SERVICE BULLETIN

M-1084 May 1, 1999

SOFTAIL AND DYNA GLIDE CARBURETOR UPDATE

Figure 1. Carburetor

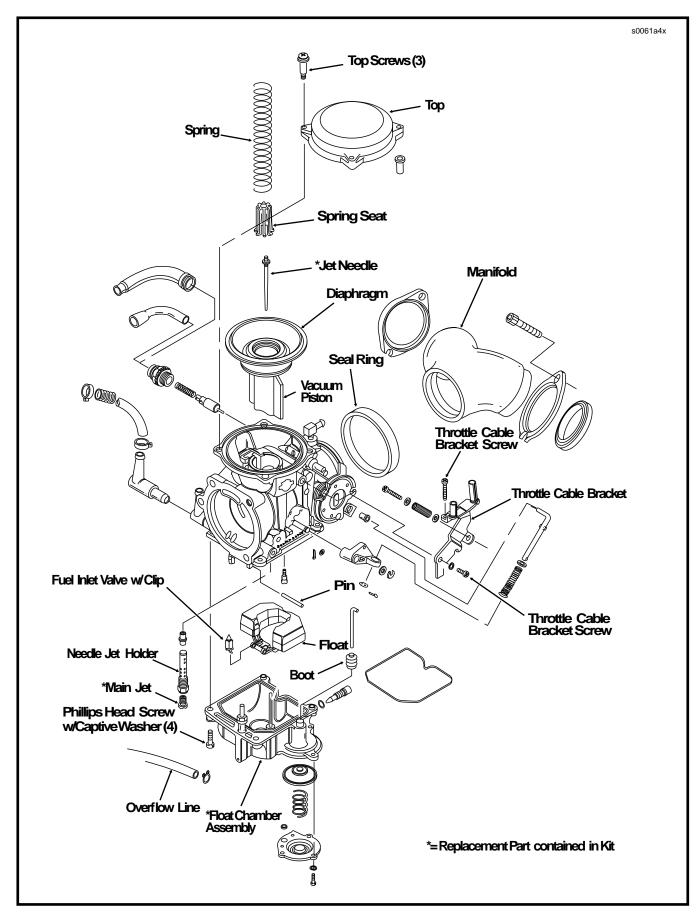
On certain Softail and Dyna Glide model motorcycles, in stock configuration, the fuel mixture may be too lean and cause the bike to run rough. This condition can be corrected by installation of the carburetor update kit, Part No. 27365-98. The kit is available to customers experiencing this drivability issue on the affected models. See Credit Procedures.

The Carburetor Update Kit, Part No. 27365-98 consists of:

Jet Needle Part No. 27255-96

Main Jet Part No. 27114-88 (Size 180)

Float Chamber Assembly Part No. 27287-98

- 1. See Figure 1. Turn carburetor upside down and remove four phillips head screws with captive washers and float chamber assembly from carburetor body.
- Hold flats of needle jet holder with an 8 mm open end wrench and remove main jet with a thin bladed flat tip screwdriver by turning counterclockwise.
- Install new main jet to needle jet holder with a flat tip screwdriver.
- 4. Install **new** float chamber assembly to carburetor body with four phillips head screws with captive washers.

- See Figure 1. Turn carburetor upright. Remove two screws and one washer that mount throttle cable bracket to carburetor body and top. Rotate throttle cable bracket clockwise, away from cover.
- Remove three top screws and washers from top. Remove top.
- Remove diaphragm and vacuum piston assembly. Inspect diaphragm for pinholes, tears or other damage. Replace if damaged.
- Remove spring and spring seat. Holding hand over upper opening of carburetor, flip carburetor upside down to allow jet needle to fall free.
- 5. Install **new** jet needle and install spring seat and spring.
